# City of Boston Response to Wharf District Council Proposal for State Street

June 2022

## *How a multiple threat crash happens*

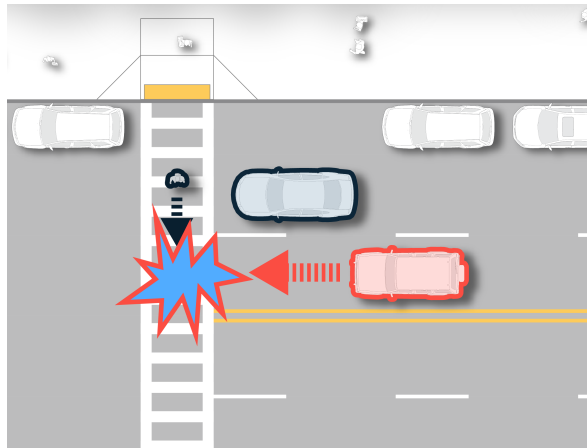
Driver 1 yields to a person waiting to cross the street. As the person begins to walk across the street, Driver 2 approaches the crosswalk in the second lane.

Driver 2 cannot see the person in the crosswalk. And, the pedestrian cannot see the car in the second lane. Their views are blocked by the car driven by Driver 1.

Driver 2 does not have enough time to react and strikes the pedestrian.

*Other streets for biking*

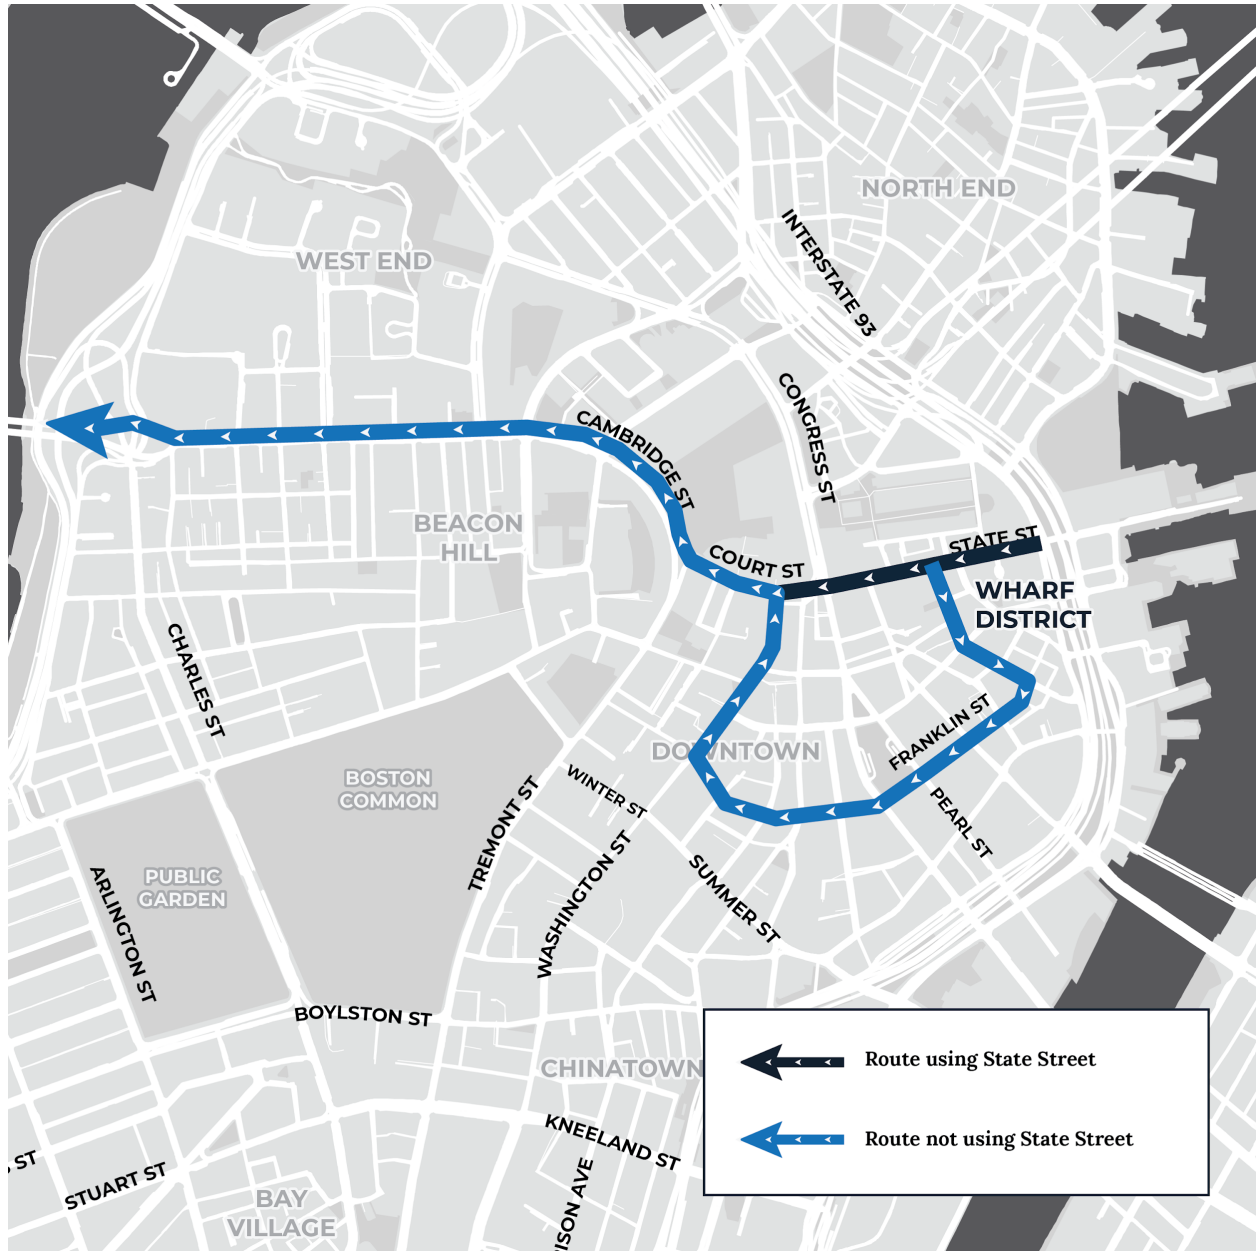
**Wharf District Council: Other streets west-bound streets are much wider, thus better for bike facilities; Hanover= 53'; Franklin = 69'; North = 94'**

[Hanover Street](#) is not a viable alternative to State Street for any travel mode as it is occupied by Haymarket street vendors on Fridays and Saturdays.

[Franklin Street](#) has several issues as an alternative bicycle route:

North Street is not a viable alternative to State Street for bicyclists.
